Well Name: BURRO CANYON

Sundry ID: 2669551

Type of Action: Plug and Abandonment

CONDITIONS OF APPROVAL

Proposed Wellbore Diagram
DJR Operating, LLC
Burro Canyon 1
API # 30-039-21152
SW/SE, Unit O, Sec 16, T24N, R4W
Rio Arriba County, NM

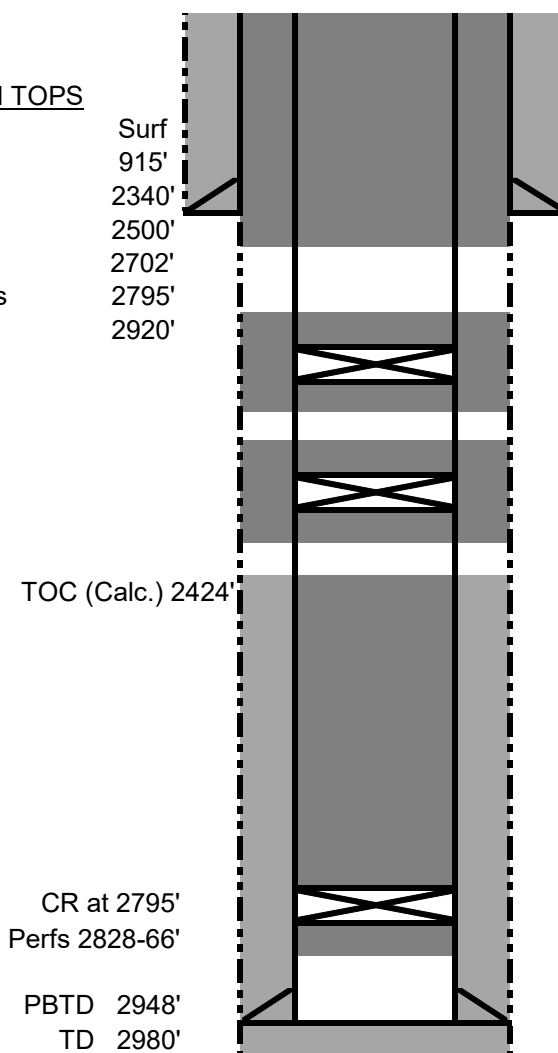
You are also required to place cement excesses per 4.2 and 4.4 of the attached General Requirements.
